# ***FALCON SERVICE BULLETIN***

## **FALCON 7X**

**No 056-R1**

**STANDARD PRACTICES  
AIRFRAME WIRING  
PROTECTION IMPROVEMENT OF VARIOUS WIRING  
ASSEMBLIES**

**Figure 1: SECTION 7X-056-1 (M876)**

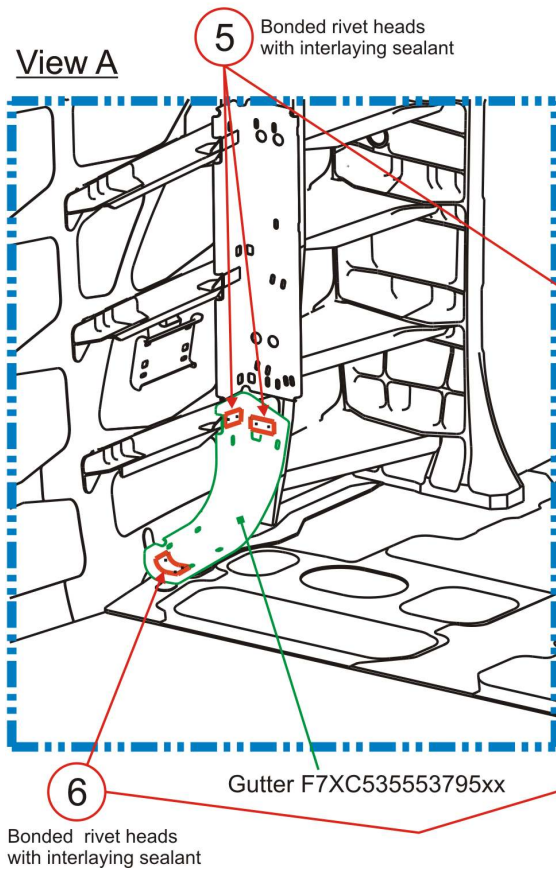
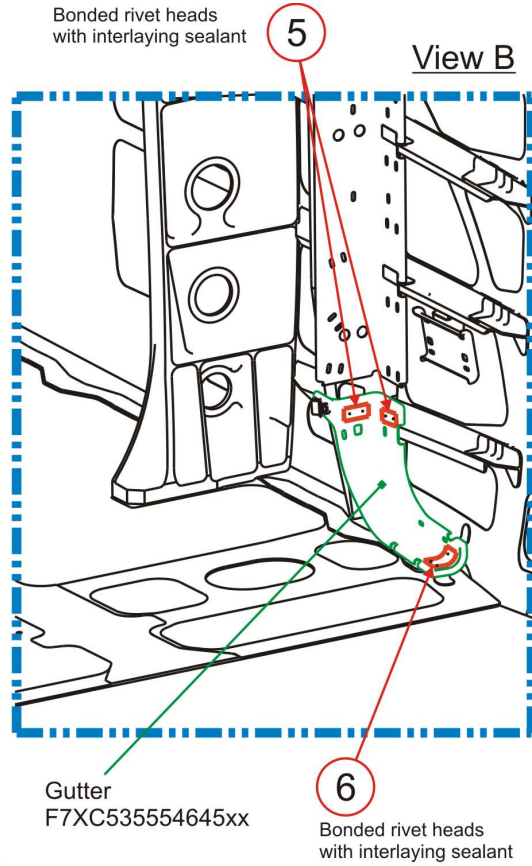
- (2) Discard the stud support (A-fig. 1).

- (3) Install the bracket (1-fig. 1).
- (4) Counterdrill the bracket and the panel at Fr 44 at dia. 2.5 mm (0.1 in).
- (5) Enlarge the holes to dia. 5.2 mm (0.2 in).
- (6) Install the new electrical bracket (1-fig. 1), using attaching parts (2, 3 and 4-fig. 1).
- (7) Clamp the electrical bundle and the surrounding pipes (if unclamped).

**Figure 2: SECTION 7X-056-2 (M897, POINT 2)**

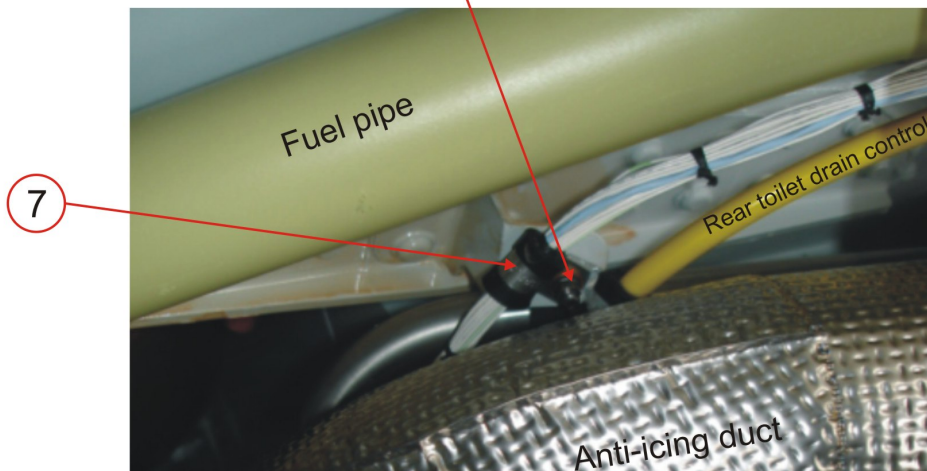
- (1) Remove:
  - (a) The LH rear FCS rack ([2003CZ](#)) (Refer to [TASK 27-90-05-900-802](#)).
  - (b) The RH rear FCS rack ([2004CZ](#)) (Refer to [TASK 27-90-05-900-804](#)).
- (2) On each side, unclamp the wiring bundles routed on the elbowed gutters to be modified.
- (3) Move the bundles away from the gutter and bond the new PTFE protective sheets (5 and 6-fig. 2) over the rivet heads, using **interlaying sealant** (Refer to [TASK 20-32-00-390-801](#)).
- (4) Allow to cure.
- (5) Secure the electrical bundle.
- (6) Install:
  - (a) The LH rear FCS rack ([2003CZ](#)) (Refer to [TASK 27-90-05-900-802](#)).
  - (b) The RH rear FCS rack ([2004CZ](#)) (Refer to [TASK 27-90-05-900-804](#)).

**Figure 3: SECTION 7X-056-3 (M900, POINT 1)**

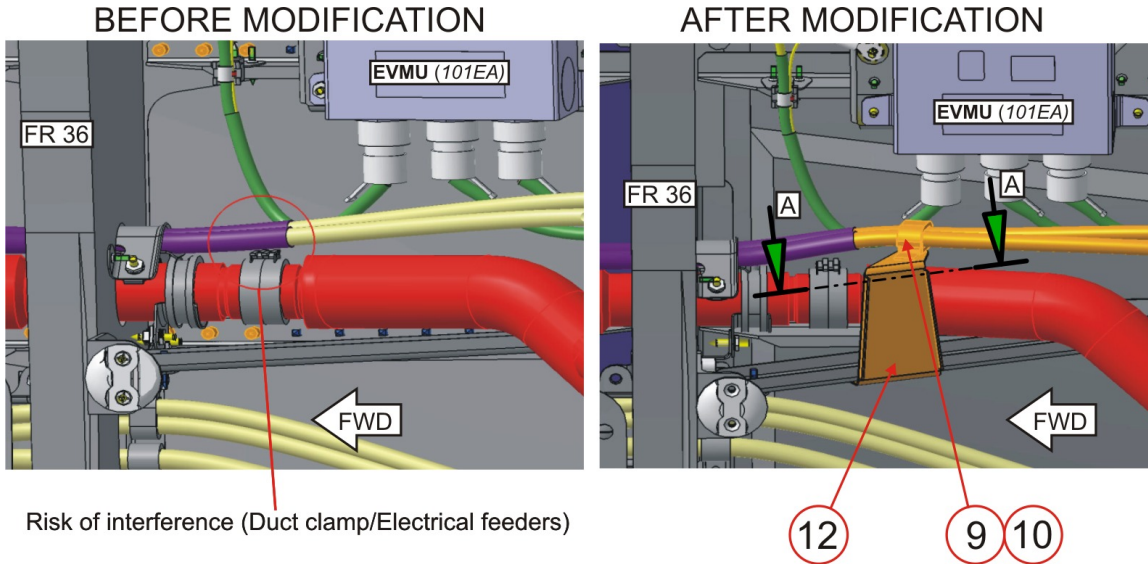
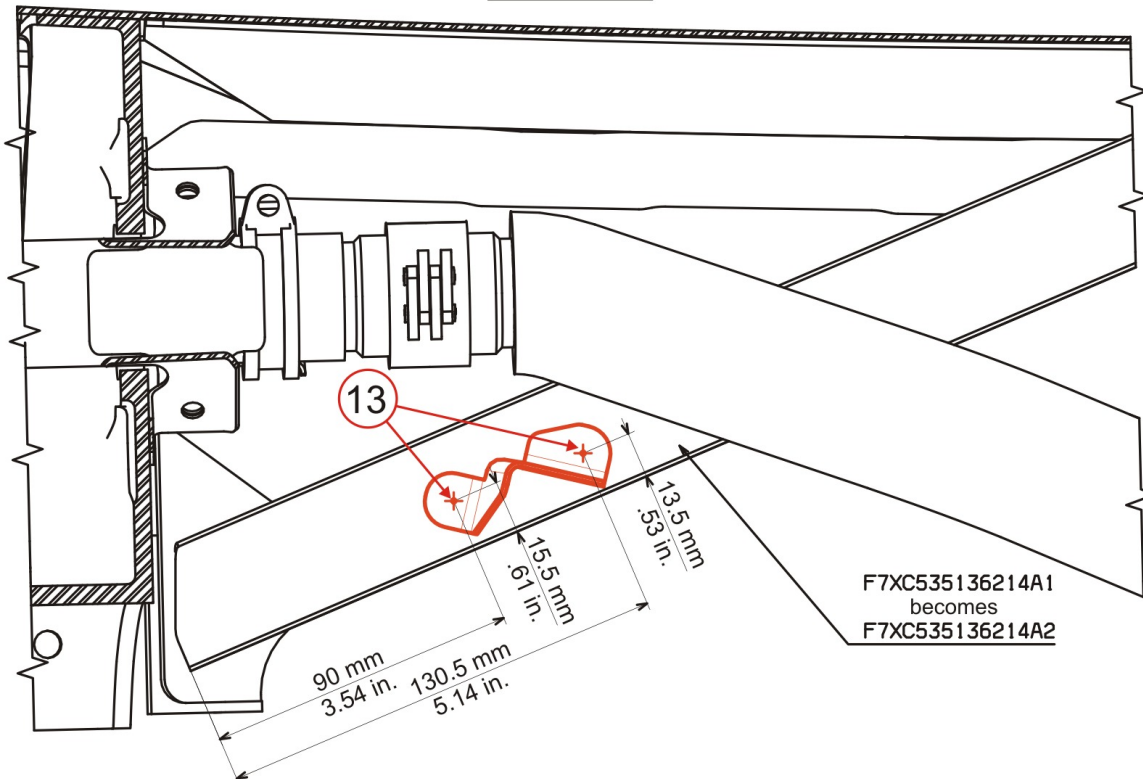
- (a) Remove the rear fuel tank rear fairing ([168AR](#)) (Refer to [TASK 53-60-00-900-801](#)).
  - (b) Secure the electrical bundle with new clamp (7-fig. 3), replace the existing screw with a new one (8-fig. 3).
  - (c) Install the rear fuel tank rear fairing ([168AR](#)) (Refer to [TASK 53-60-00-900-801](#)).
- (2) Point 2 (Baggage compartment)

**Figure 4: SECTION 7X-056-3 (M900, POINT 2)**

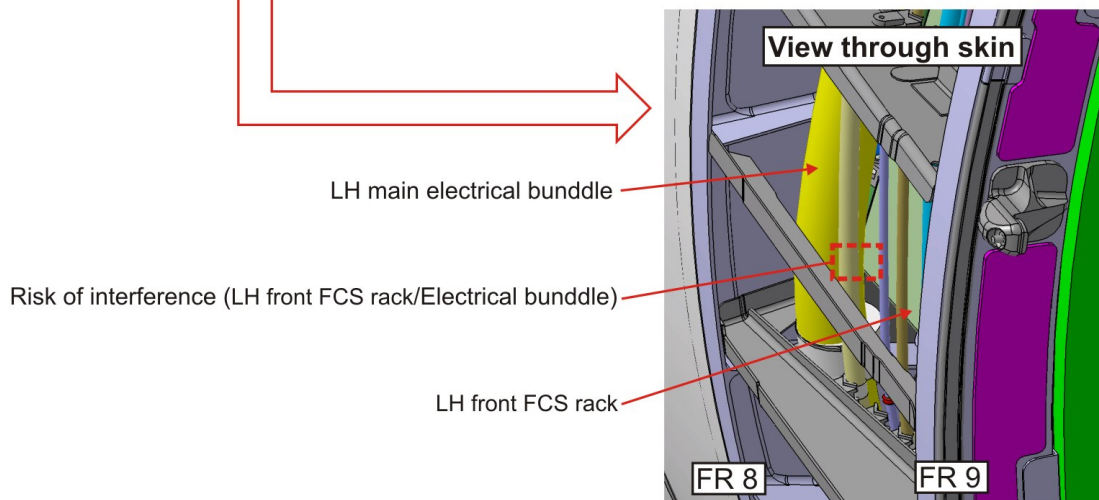
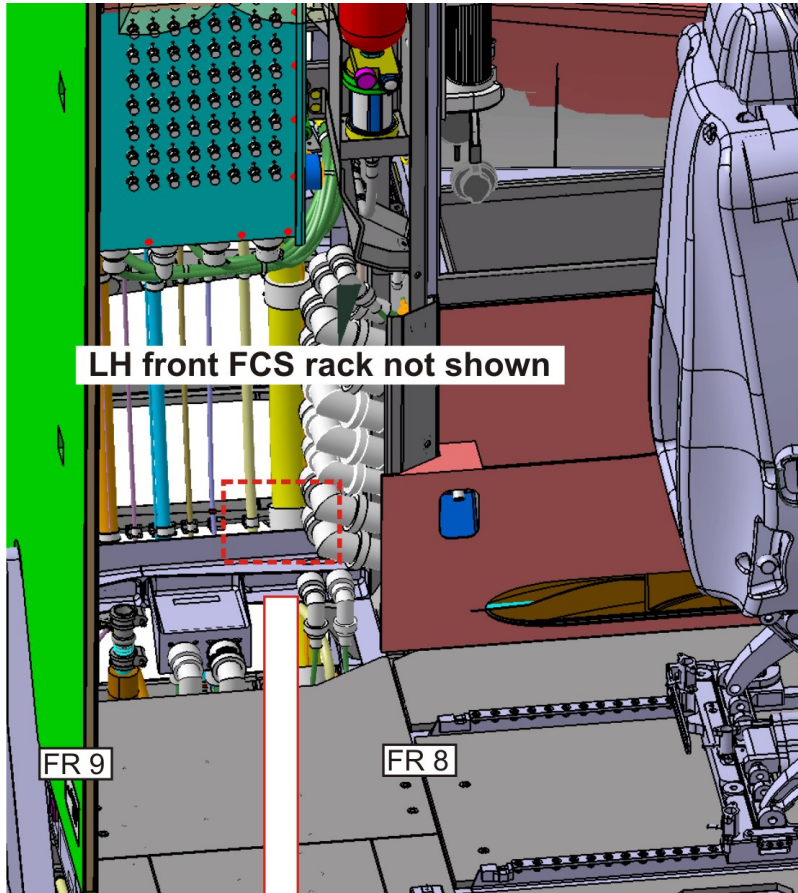
- (b) Position the new bracket (12-fig. 4) on the stiffener.
  - (c) Drill the stiffener to a dia. 2.5 mm (0.01 in.).
  - (d) Counterdrill the new bracket (12-fig. 4) and the stiffener for new rivets (13-fig. 4).

- (e) Install the bracket (12-fig. 4), using rivets (13-fig. 4).
  - (f) Identify the stiffener with its new P/N F7XC535136214A2.
  - (g) Secure the electrical feeders on the bracket, using new clamp (9-fig. 4) and nut (10-fig. 4).

**Figure 6: SECTION 7X-056-3 (M900, POINT 3)**

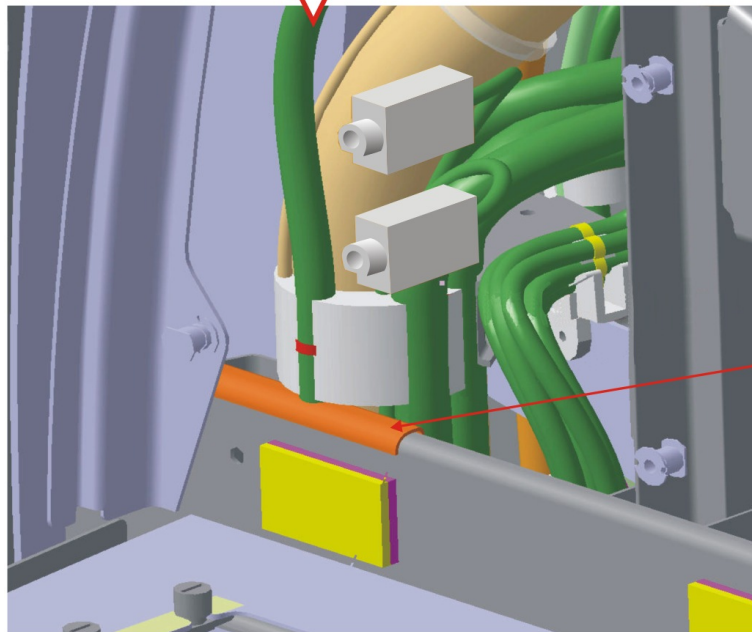
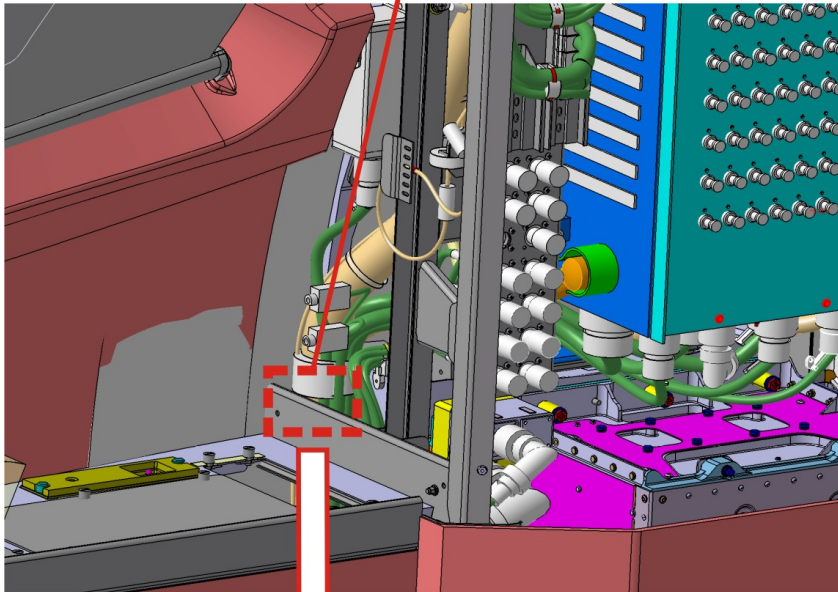
- (c) Remove the three brackets from the web (one detempel bracket and two stud supports).
  - (d) Install new rivet (27-fig. 6) to plug unused hole.
  - (e) Counterdrill the new bracket (15-fig. 6) according to the web holes.

- (f) Install the new bracket (15-fig. 6) on the web, using rivets (25 and 26-fig. 6).
  - (g) Form the LH main electrical bundle for the new clamp (16-fig. 6).

- (h) Attach the clamp (16-fig. 6) on the new bracket (15-fig. 6), using screws and washers (19 and 20-fig. 6).
  - (i) Secure the LH base feeder and the Cockpit fuse harness on the new bracket (15-fig. 6), using clamps (17 and 18-fig. 6) and nut (21-fig. 6).

**Figure 7: SECTION 7X-056-3 (M900, POINT 4)**

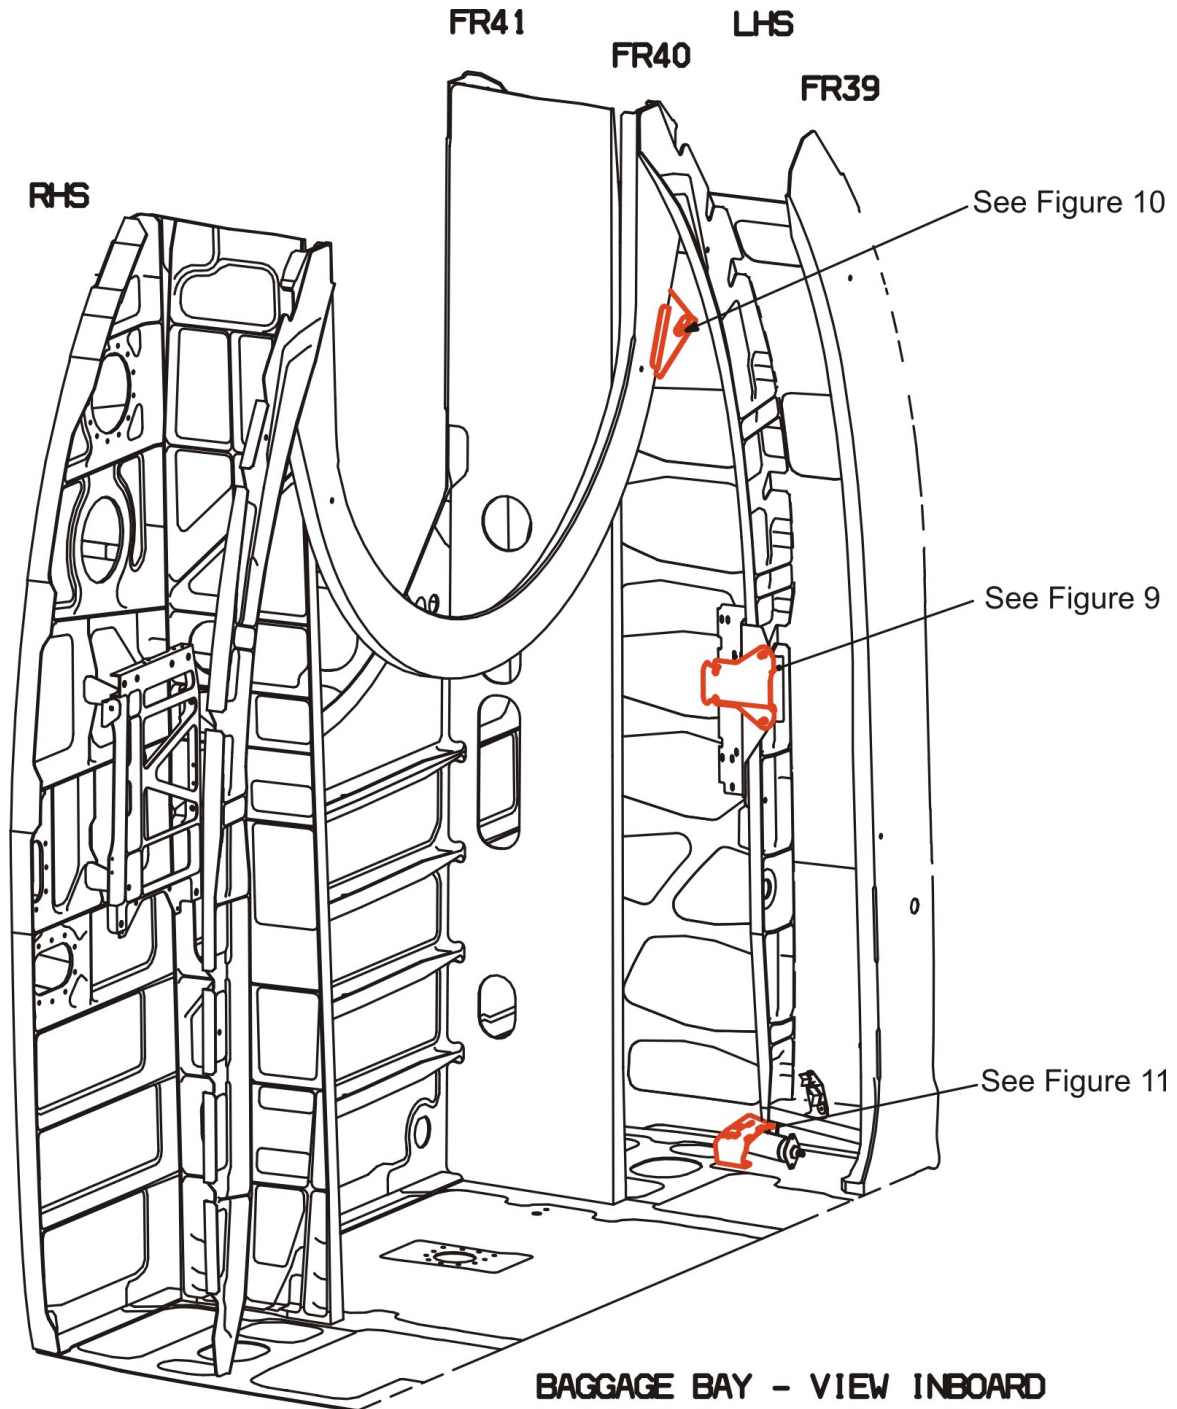
- (c) Bond the new protective sheet (28-fig. 7) to the crossbeam, using **interlaying sealant** (Refer to **TASK 20-32-00-390-801**).
  - (d) Allow to cure.

Risk of interference (RH cabinet structure/Electrical bundle)
